1 OLD CONNA WASTE WATER PUMPING STATION

Purpose		FOR PLANNING			
Title		PROPOSED PUMP STATION & EMERGENCY 24hr STORAGE TANK SITE LAYOUT PLAN			
Original Scale	Drawn	Checked	Reviewed	Authorised	
1:200 at A1	PM	PS	PS	GH	
1:400 at A3	Date 31.09.26	Date 31.09.26	Date 31.09.26	Date 31.09.26	
Status	Drawing Number				Rev
S4	ATK-ZZ-ZZ-DR-CE-900572				P02

Irish Water Form IW-AD-EDS-FM-003			Project Design Review Contract Document and Comments Tracker		
Workshop Date:					
			WS4		
			IDD Portfolio Manager		
			ESP Feedback / Comments		
Document	Participant Name	Query ID	IW Observations / Comment	ESP Feedback / Comments	Addressed by
Planning WWPS and RM Design Report - Phase A1	Padraig Hanly	ADRL 4.1	Section 2.2 of Report - Masterplan comments sent back by UE for response. WS4 Detailed Design and WS 5 Hazop to occur later when the detailed design for the project is complete.	Noted	AtkinsRéalis
Planning WWPS and RM Design Report - Phase A1	Padraig Hanly	ADRL 4.2	Section 2.2 of report - Mentioned that character areas may change later as development plans progress. The levels of the WWPS are now being set through the review and acceptance of the masterplan and proposed WWPS inlet levels. If

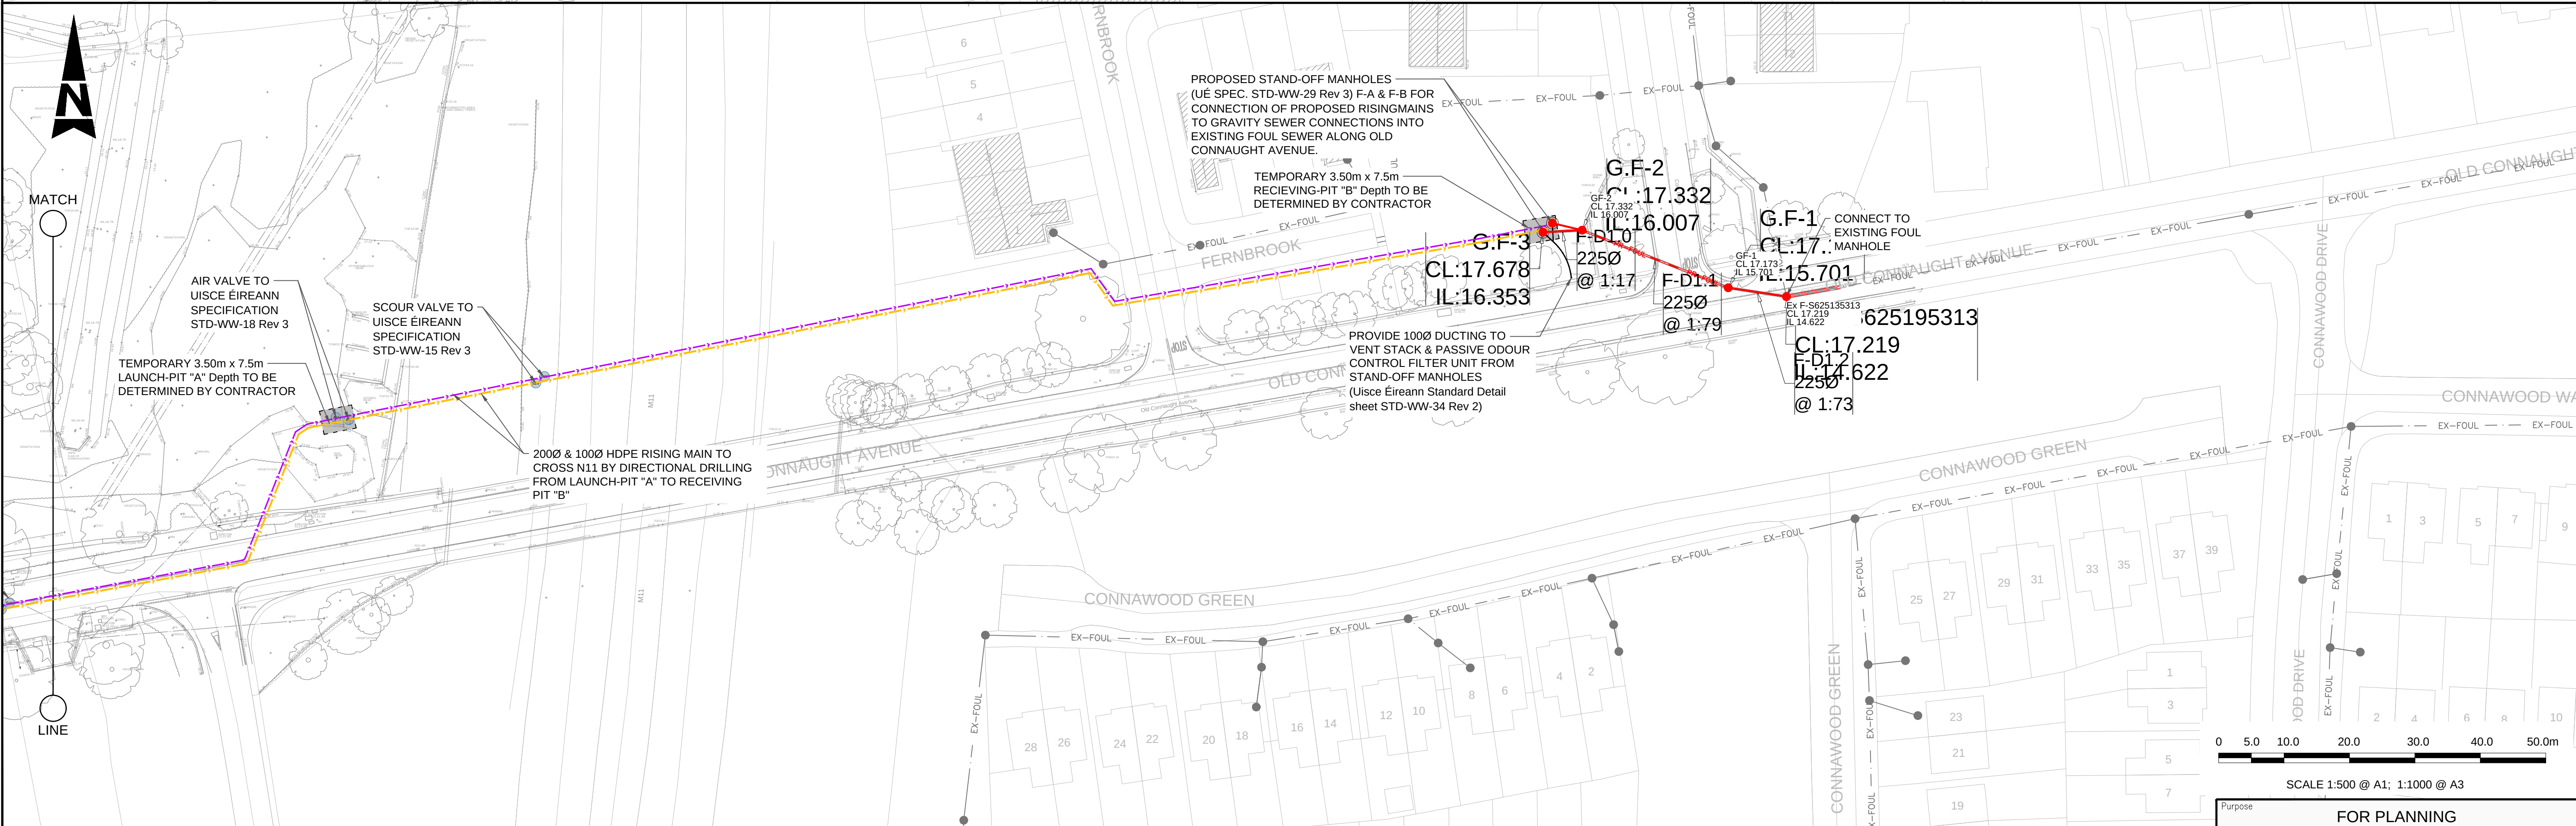
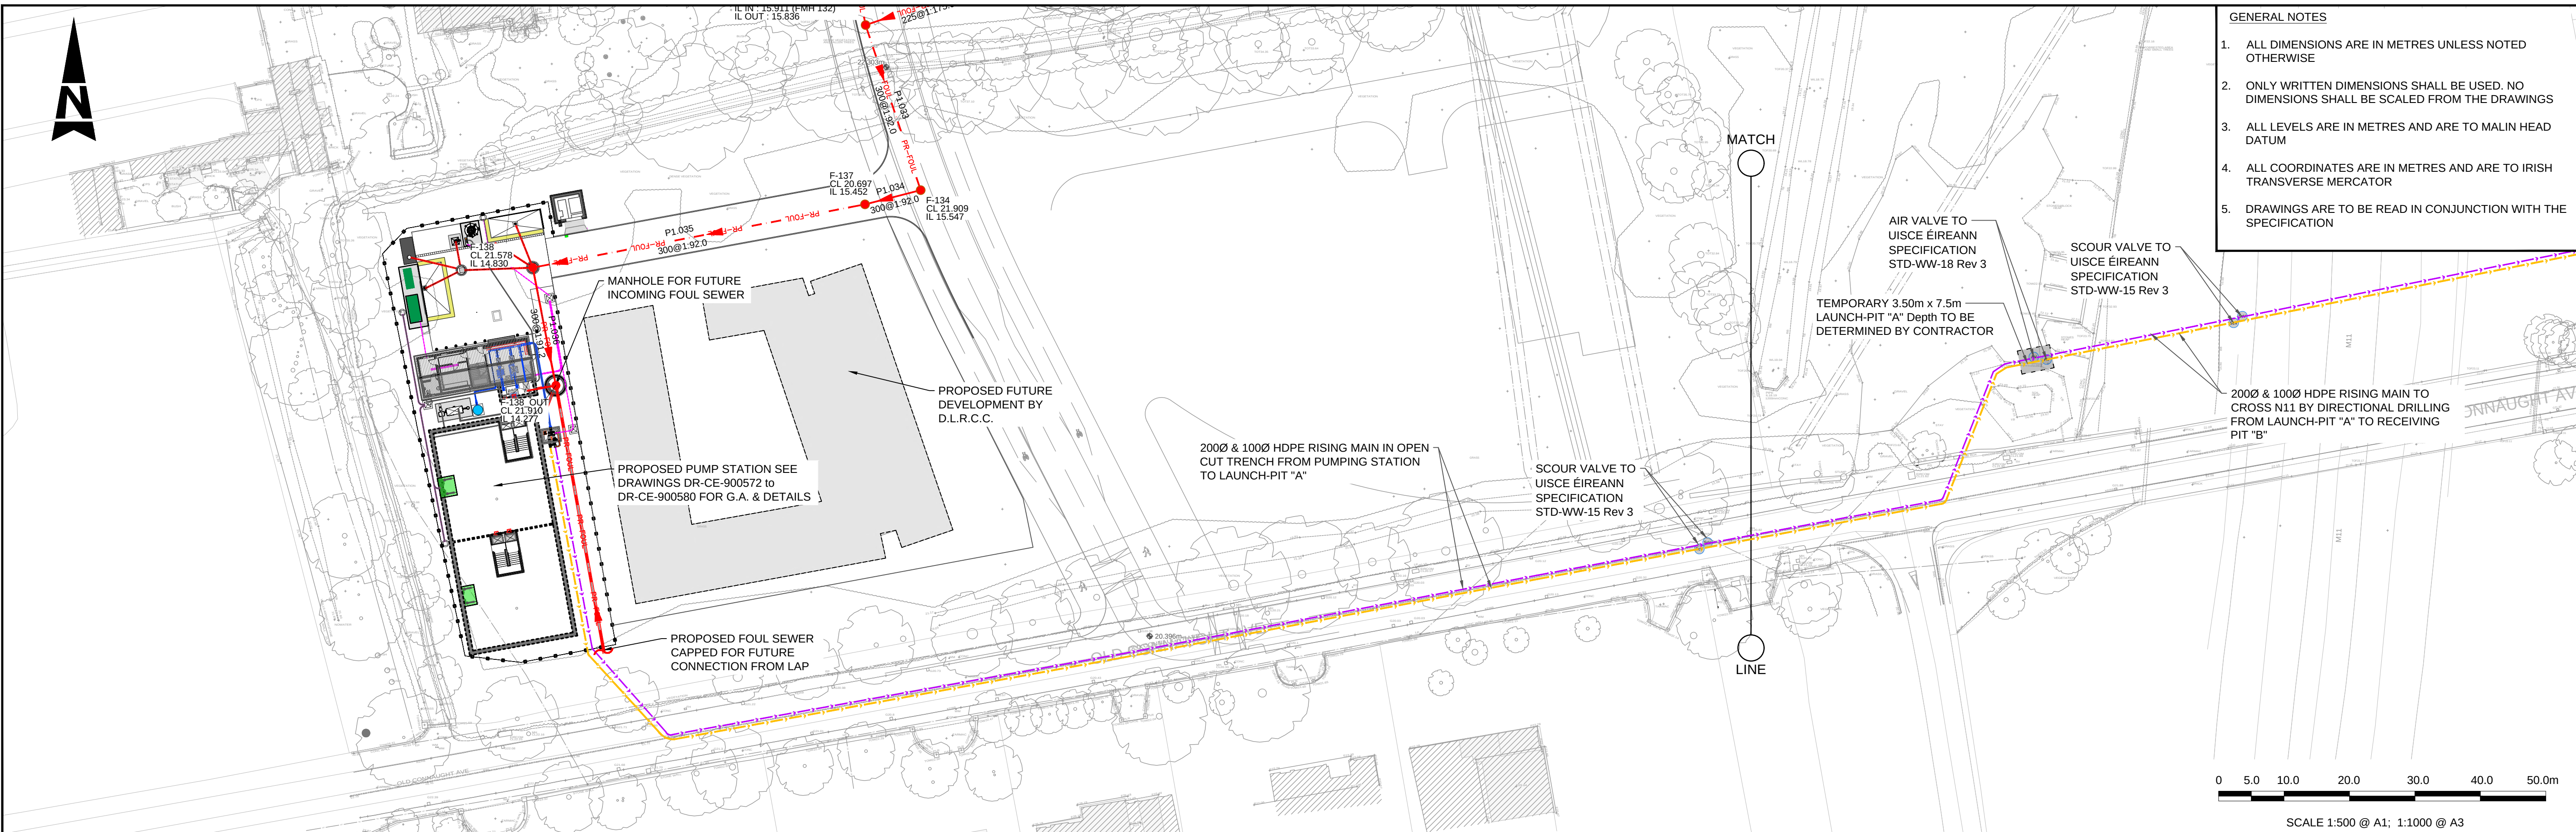
Old Conna LAP Overall Foul Drainage Strategy	Atkins (UE)	ADES 4.3	The layouts should note where they plan to cross existing services and the depth of same.	Please refer to AtkinsRéalis drawing ATK-ZZ-ZZ-DR-CE-900580 for route of rising main, M11 road crossing and final tie in location to the existing WW network on Old Connaught Avenue. Note as requested by UE on the 28/07/26 as spur from the PS inlet manhole has been provide to allow for connection from the network to the South.	AtkinsRéalis
Old Conna LAP Overall Foul Drainage Strategy	Atkins (UE)	ADES 4.4	Include Rising main, road crossing and tie in point to existing WW network	Pump Located at level of circa 12.130mOD. Initial pump calculations take account of head within the rising main and head loss along the distance of the rising main.	AtkinsRéalis
Planning WWPS and RM Design Report - Phase A1	Atkins (UE)	ADES 4.5	Inlet invert level indicated in the drawings is 14.277 (Dwg No. 900677) but the pump size calculations consider 21m	Initial Submergence and clearance has been determined, however, final checks to be completed at detailed design stage depending on pump selection.	AtkinsRéalis
